<b>Subject:</b>  SQUEAKING/GRINDING NOISE FROM REAR BRAKE	<b>Bulletin No:</b> 04-003/15
	<b>Last Issued:</b> 11/06/2015

- This bulletin supersedes the previous bulletin 04-003/15 issued on 09/16/15. The PART(S) INFORMATION has been revised.
- Changes are noted below in Red beside the change bar.

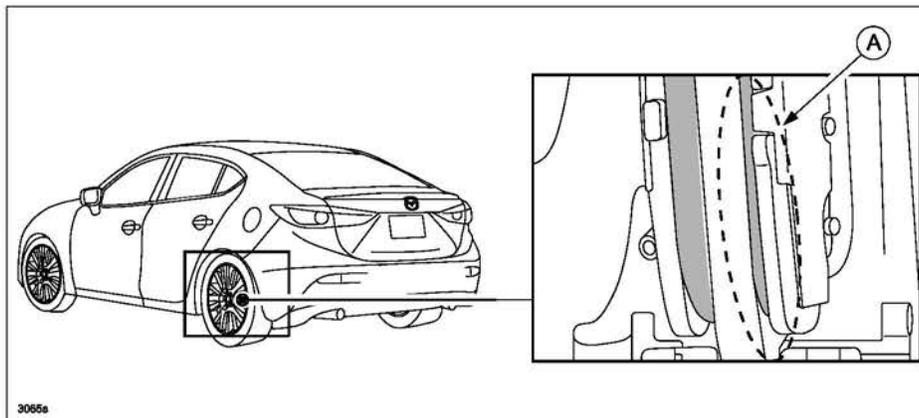
Some vehicles may experience a squeaking/grinding noise from the rear brake even after the brake pedal is released. Upon inspection, the caliper mounting support is corroded and the disc pad is abnormally worn out (A). This is caused by vehicle usage in an area using road salt. The surface of the mounting support may swell from corrosion causing premature disc pad wear and brake noise.

To correct the problem, an improved caliper mounting support has been newly established as a service part. The anti-corrosion surface treatment has been changed from Zn to Zn-Ni plating.
